Site Plan Review FCC Environmental Services 560 Randolph Ave

**Zoning Committee Public Hearing – April 24, 2025
File #25-015-397**

FCC Environmental Services – 560 Randolph Ave

Site Plan Scope and Staff Review

Existing Conditions

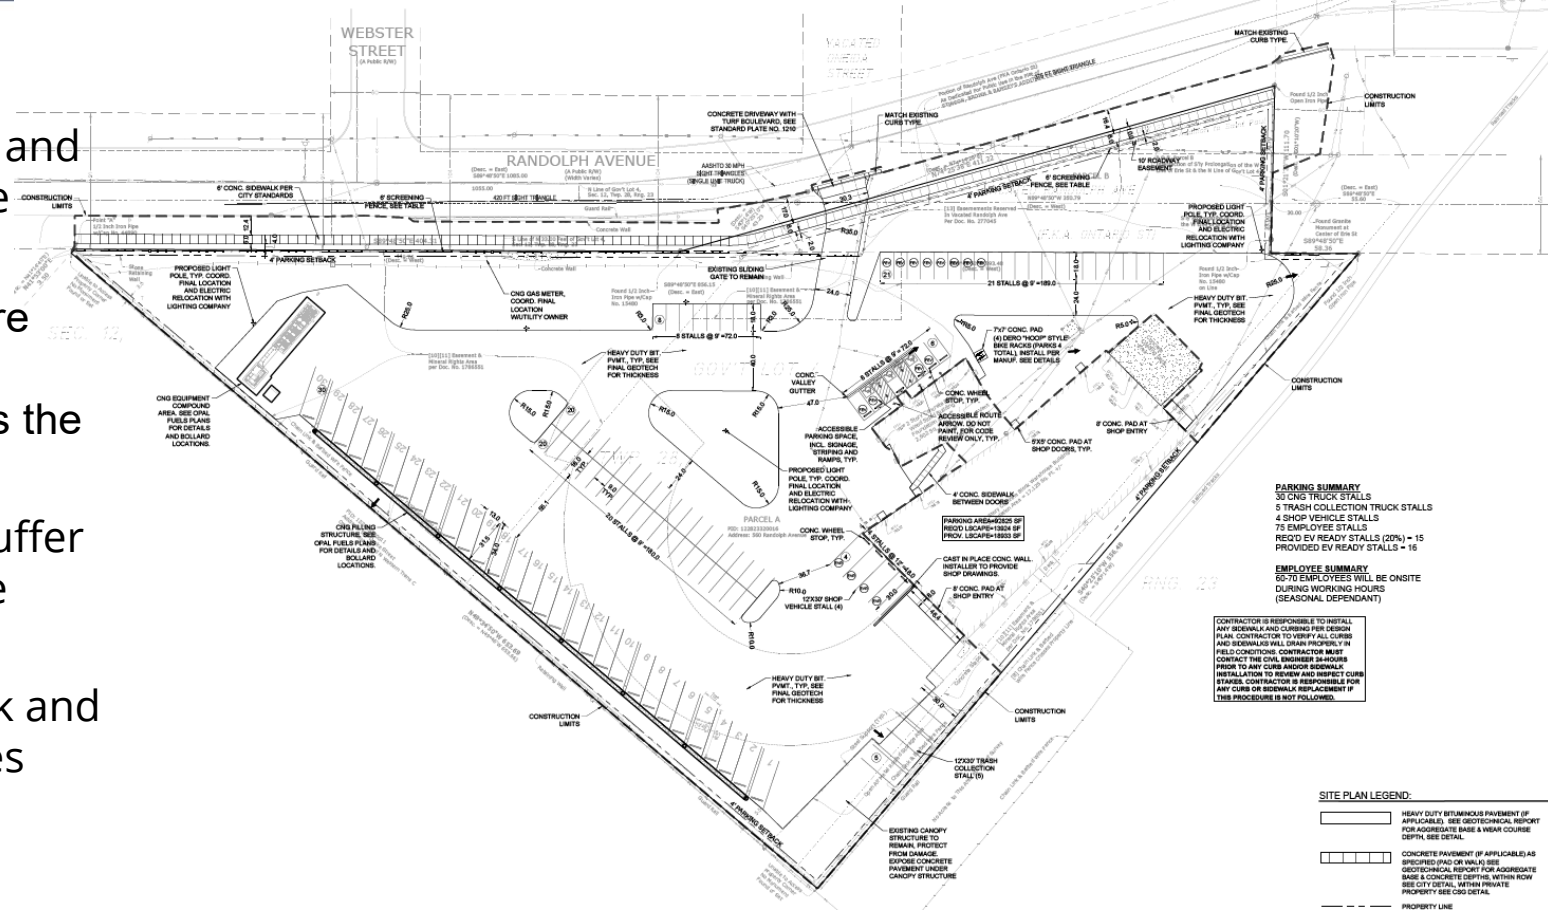
- Admin/office buildings
- Most recent use was a tow truck operator
- Unpaved, gravel lot
- Perimeter chain link and barbed wire fence
- No adjoining public sidewalk or trees

City's adopted comprehensive plan and development or project plans for sub-areas of the City

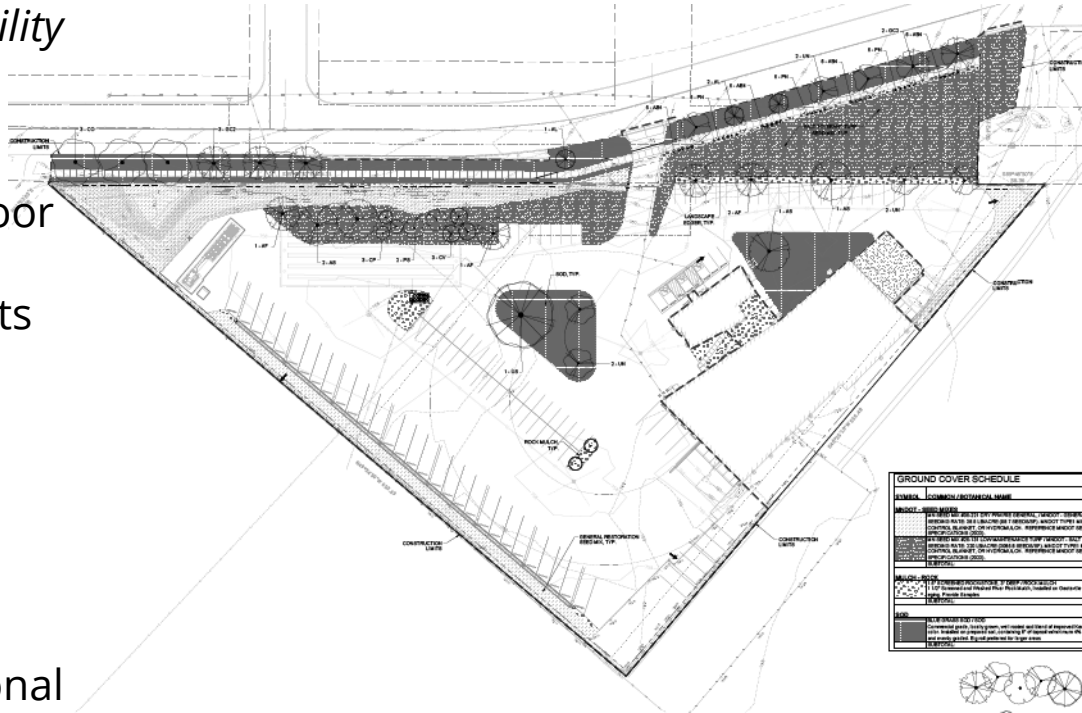
- The 2040 Saint Paul Comprehensive Plan designates the site's **future land use as Industrial**
 - 560 Randolph Avenue is **zoned I1 Light Industrial** which allows a wide variety of permitted uses
 - Multiple Comp Plan Policies promote mixed-use and industrial zoning
- Four Comprehensive Plan addenda foresee the site as **possible residential land use in long-term**
 - **No rezoning** or other amendments were initiated based on area plans to alter the site's industrial zoning designation
- The **2040 Comp Plan governs if there are conflicts** with small area plans

Applicable ordinances of the City of Saint Paul

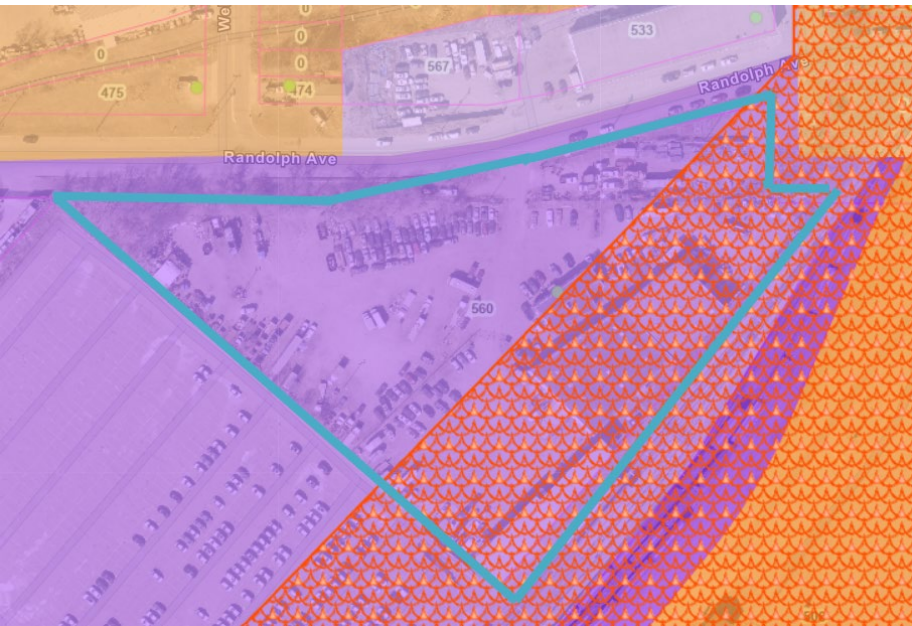
A Public Works Yard or Maintenance Facility is an **allowed land use** in an I1 zoning district

Site improvements for parking, outdoor fleet vehicle storage, and fueling area, **comply** with Zoning Code requirements including:

- New in-fill public sidewalk and boulevard trees
- Outdoor storage screening
- Consolidated driveway access
- Off-street parking design, dimensional and landscaping standards

Protection of adjacent and neighboring properties through reasonable provision for such matters as surface water drainage, sound and sight buffers, preservation of views, light and air, and those aspects of design which may have substantial effects on neighboring land uses

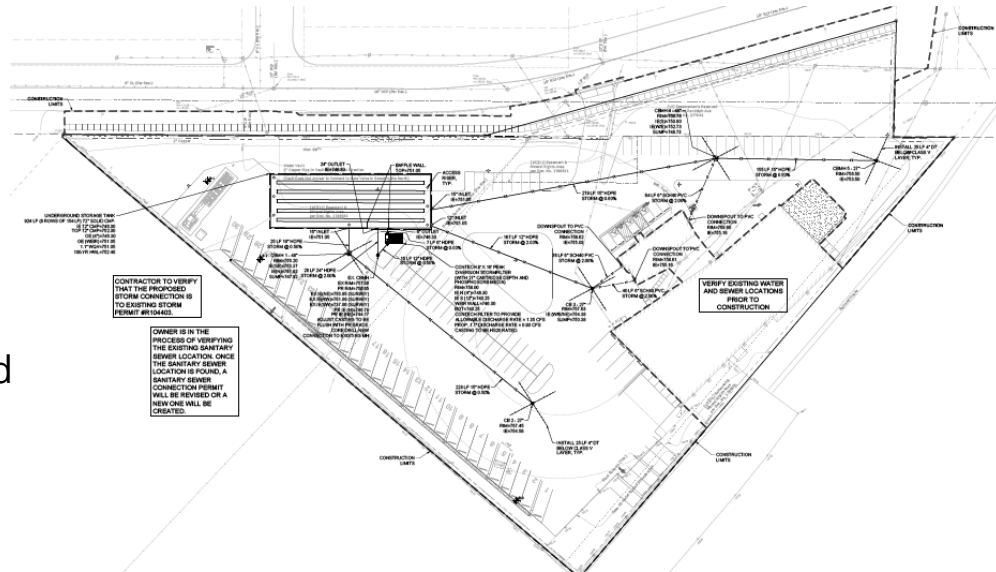
- Stormwater runoff will be improved by best management practices (BMPs)
 - City's stormwater run-off rate control and Watershed stormwater quality requirements
- The CNG station will not store or produce materials or waste that will contaminate surface or ground water
- CNG operations shall be conducted, operated and maintained in accordance with any necessary permits of the state pollution control agency, the county and the city

- Parking setback significantly exceeds the min 4-foot setback requirement, buffering abutting properties from the facility
- Parking and outdoor storage design standards for landscaping, tree planting, screening, and lighting are met

Safety and convenience of vehicular and pedestrian traffic both within the site and in relation to access streets, including traffic circulation features, the locations and design of entrances and exits and parking areas within the site

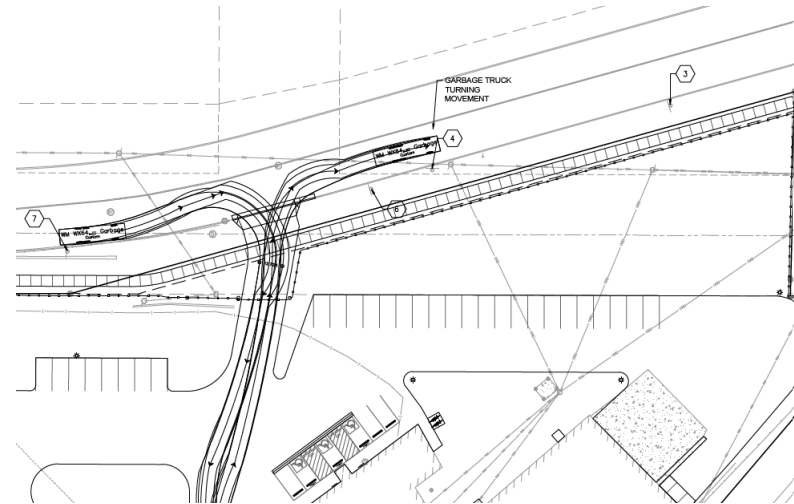
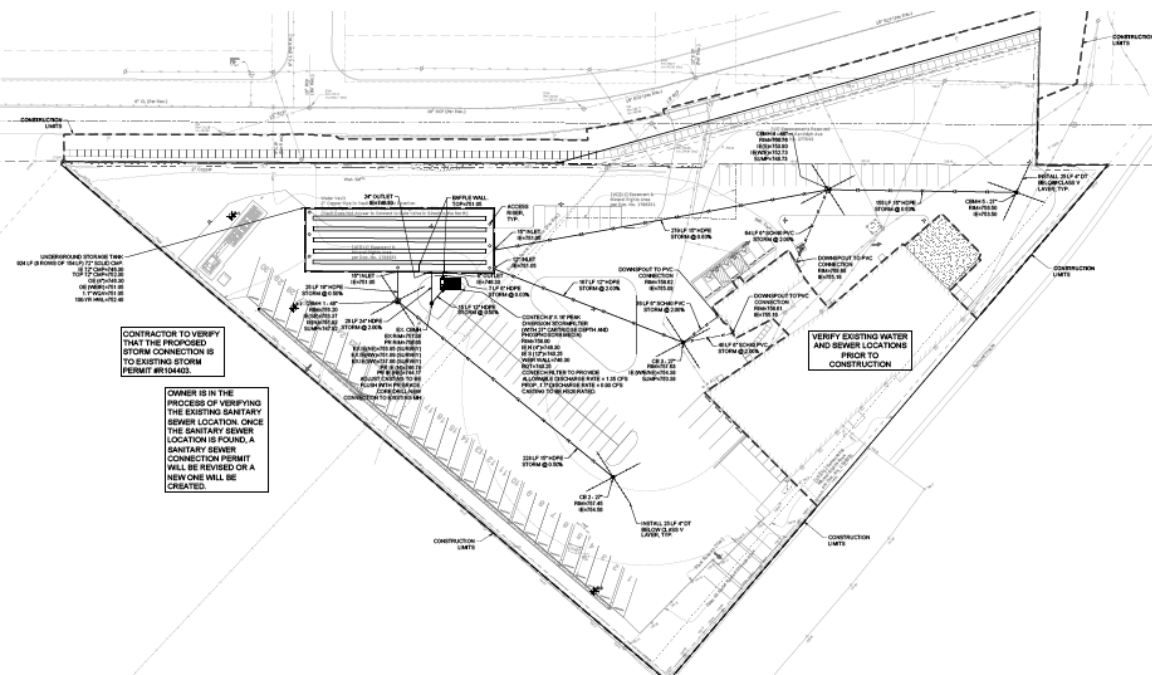
- Transportation Study assessed vehicle trip generation and traffic impact of FCC's operations
- Parking and vehicle storage are located interior to 4-acre property
- Accessed off Randolph Ave, a collector street and Ramsey Co right-of-way
- Existing driveways to be consolidated and right-sized for the fleet vehicles
- Public Works and Ramsey County refined site improvements to enhance pedestrian safety including boulevard expansion and location of new public sidewalk

The satisfactory availability and capacity of storm and sanitary sewers, including solutions to any drainage problems in the area of the development

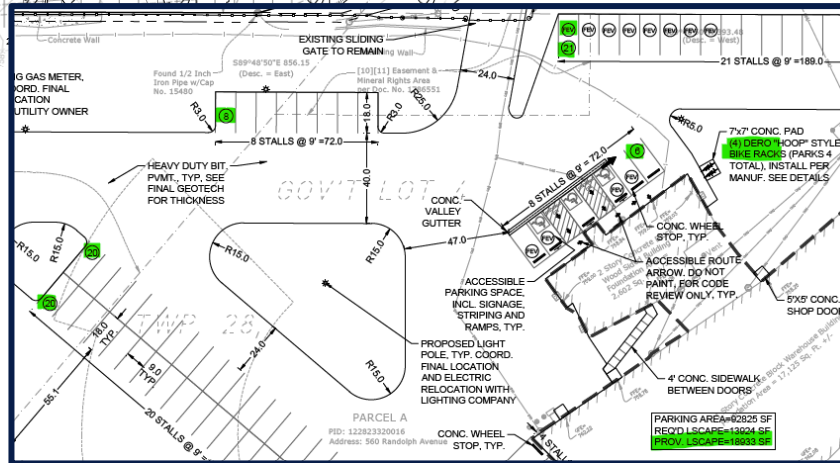
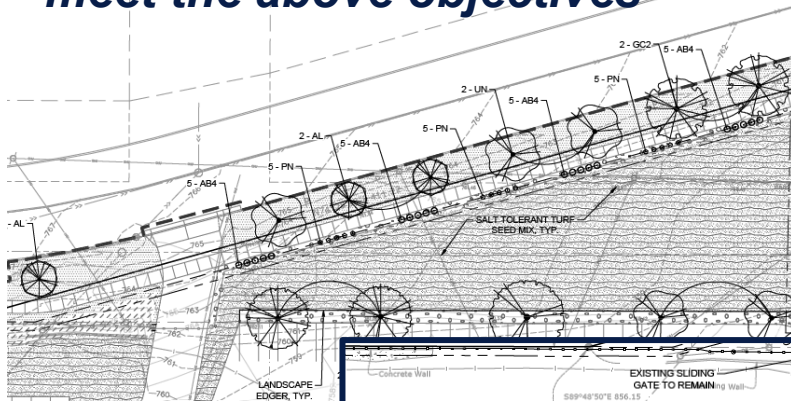
- Availability and capacity of public storm and sanitary sewers are deemed satisfactory
- Stormwater runoff will be improved by best management practices (BMPs) to meet City and Watershed District treatment requirements
- Utility services will be connected to existing public infrastructure under PW Sewers Permits
- Existing septic system to be removed and connection made to public sanitary utility

Sufficient landscaping, fences, walls and parking necessary to meet the above objectives

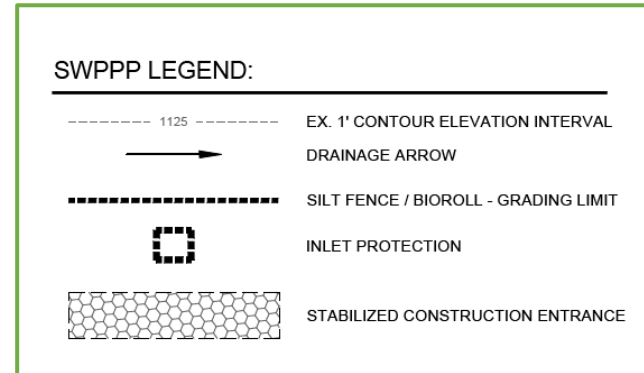
- New boulevard trees will be planted along Randolph Ave
- Decorative, six-foot tall, obscuring fence and landscaping along Randolph Ave property line serves to screen the outdoor storage
- 75 surface off-street parking spaces, includes:
 - 16 electric-vehicle ready spaces
 - 3 ADA spaces
